OVERLOOK STATION SUBDIVISION

APPLICATION NUMBER 8 DATE May 3, 2007

REQUEST Subdivision

DETAIL SITE PLAN

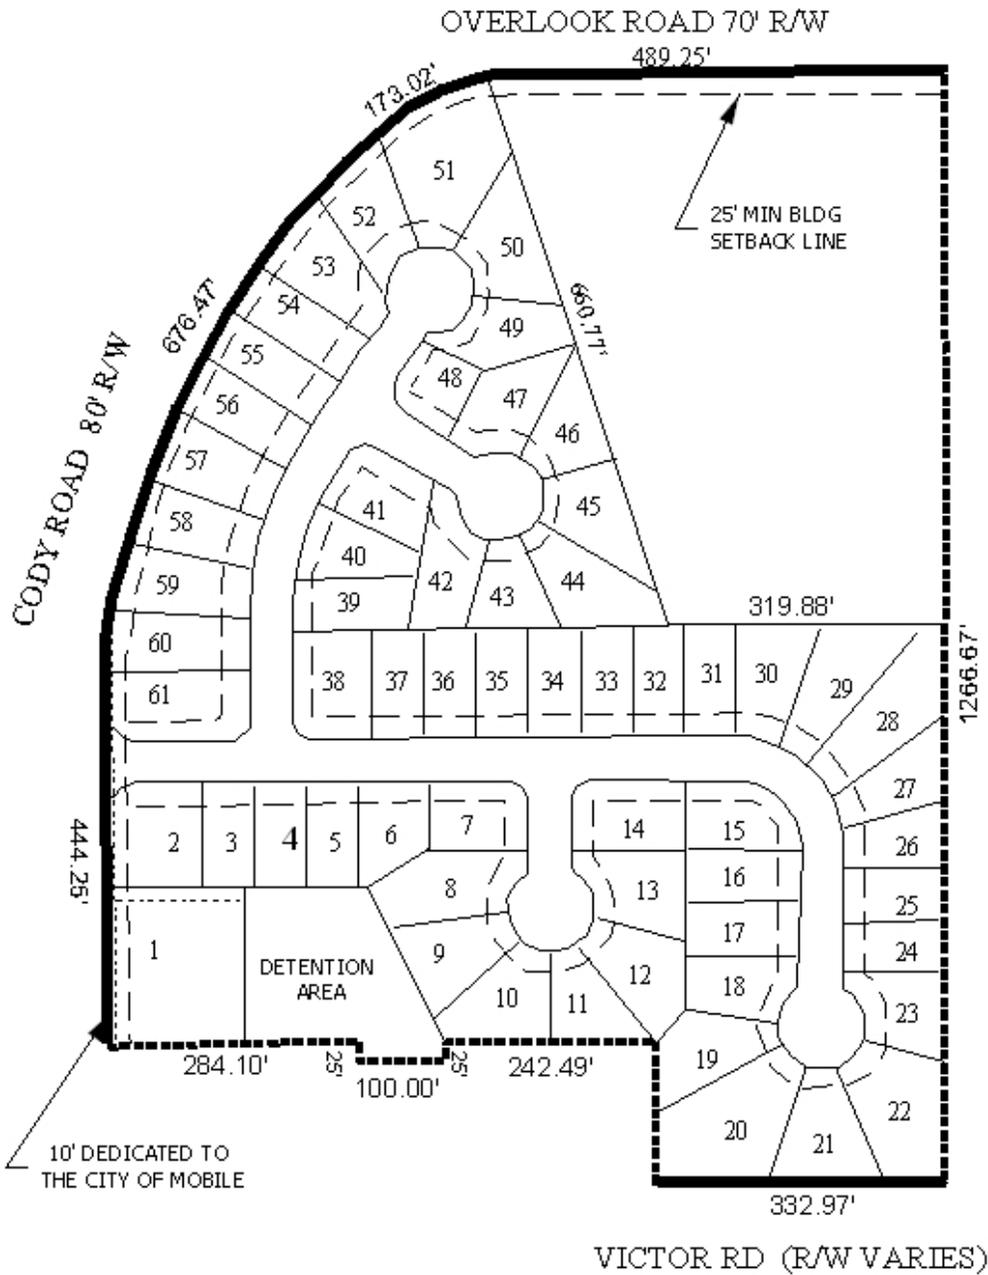
The 25-foot minimum building setback line, which is depicted on the plat, should be adjusted to reflect right-of-way dedication along Cody Road. The minimum building setback line should also be depicted along the rear of the lots with frontage on Victor Road.

Access management is a concern due to the site's frontage onto three streets. Lots 2 through 61, which have frontage onto new streets proposed as part of the subdivision, should be denied access to Cody Road, Victor Road and Overlook Road. Lot 1 should be allowed two curb-cuts onto Cody Road, with one of the curb-cuts exclusively for the drainage and utility easement that leads to the detention area for the subdivision. Lot 62, which will contain the existing church, should be limited to a maximum of three curb-cuts. The size, design and location of all curb-cuts are to be approved by Traffic Engineering and conform to AASHTO standards.

The site involves the creation of new streets. Because the site adjoins an approved subdivision to the East, a street-stub should be provided in the vicinity of Lots 23 and 24 in order to connect with the approved Overlook Place subdivision.

All lots appear to meet the minimum size requirements of the Subdivision Regulations, however, the plat should be revised to label each lot with its size in square feet, or a table should be provided on the plat with the same information.

The detention area and any other common areas should be labeled as common areas, and a note should be placed on the final plat, if approved, stating that maintenance of the common areas is the responsibility of the property owners.

- 1) submission of applications (one for the residential portion of the site and one for the church portion of the site are recommended) to remove the split-zoning condition for the site, and the applications necessary to allow the church to operate on Lot 62 (Planning Approval, if rezoned to residential, and Planned Unit Development for multiple buildings on a single building site), prior to the signing of the final plat;

- 2) placement of a note on the final plat stating that Lot 1 is limited to two curb-cuts onto Cody Road, with one curb-cut dedicated to the drainage and utility easement, that Lot 62 is limited to three curb-cuts onto Overlook Road, and that Lots 2-61 are denied access to Cody, Victor and Overlook Roads, with the size, design and location of all curb-cuts to be approved by Traffic Engineering and conform to AASHTO standards;

- 3) revision of the plat to provide a street stub in the vicinity of Lots 23 and 24 to the approved Overlook Place subdivision to the East;
- 4) revision of the plat to label each lot with its size in square feet, or provision of a table on the plat with the same information;

- 5) revision of the plat to label all common areas, including the detention area, and the placement of a note on the plat stating that the maintenance of common areas is the responsibility of property owners; and
